Access Compliance Report

Public Rights-of-Way

(Curb Ramps)

Intersection ID: 10029283	Main Street: JOSEPH_HOWARD_CT	Cross Street: N/A	Location: W
ADA ID: 4C1F9F1189CD	Ramp Type: Perp	Initial Pass/Fail: Fail	Overall Compliance: No
Codes/Mitigation Info/Possible Solution		Field Measurements/Component Compliance	
Severity Score: 10

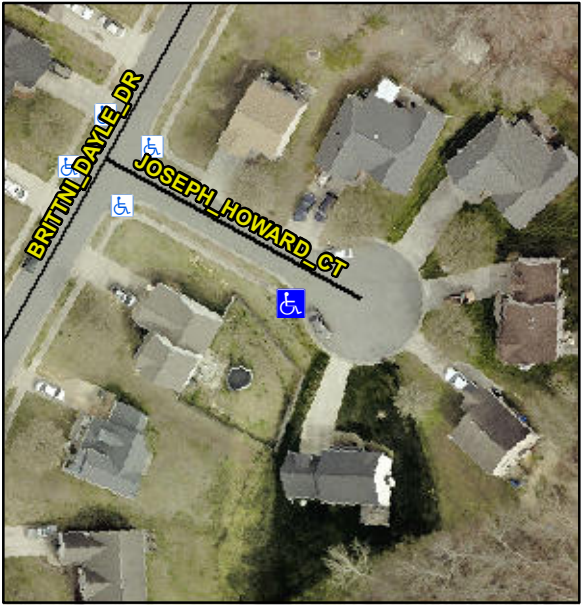
Possible Solutions:	Compliance	Description	Data	Compliance	Description	Data
	Remove & Replace Entire Ramp.	N/A	Ramp Length (in)	50.5	Yes	Ramp Slope (%)	8.0
		No	Ramp Width (in)	39.5	Yes	Ramp XSlope (%)	3.0
		N/A	Flare Type LT	N/A	N/A	Flare Type RT	N/A
		N/A	Flare Slope LT (%)	N/A	N/A	Flare Slope RT (%)	N/A
		N/A	Flare Traversable LT?	N/A	N/A	Flare Traversable RT?	N/A
		N/A	Landing Length (in)	N/A	N/A	DWS Provided?	N/A
		N/A	Landing Width (in)	N/A	N/A	DWS Contrast?	N/A
		N/A	Landing Slope (%)	N/A	N/A	DWS Length (in)	N/A
		N/A	Landing X Slope (%)	N/A	N/A	DWS Full Width?	N/A
<p>Surveyor Notes:</p> <p>N/A</p> <p>PROW/ADA:</p> <p>R304.5.1</p>		N/A	Landing Curb? (Y/N)	N/A	N/A	DWS Offset (in)	N/A
		N/A	Shared Landing?	N/A			
		N/A	Gutter Ponding?	N/A	N/A	Gutter Slope (%)	N/A
		N/A	Gutter Lip Ht (in)	N/A	N/A	Gutter X Slope (%)	N/A
		N/A	Painted X Walk1?	No	N/A	Painted X Walk2?	N/A
			X Walk 1 Direction	To E		X Walk 2 Direction	N/A

N/A	X Walk 1 Width (in)	N/A	N/A	X Walk 2 Width (in)	N/A
			X Walk 1 Slope (%)	2.2		X Walk 2 Slope (%)	N/A
			X Walk 1 X Slope (%)	6.0		X Walk 2 X Slope (%)	N/A
		N/A	Ramp inside XWalk1?	N/A	N/A	Ramp inside XWalk2?	N/A
<p>Total Cost:</p> <p>\$ 1850.00</p>			Road Slope (%)	N/A	N/A	Clear Space?	N/A
			Road X Slope (%)	N/A	N/A	Clear Space to XWalk (in)	N/A
		N/A	Any Obstructions?	N/A	N/A	Storm Grate/Utility Hazard?	N/A
			Obstruction Type			Storm Grate/Utility Type	
					N/A		N/A
					Yes	Surface Condition? (G/P)	Good
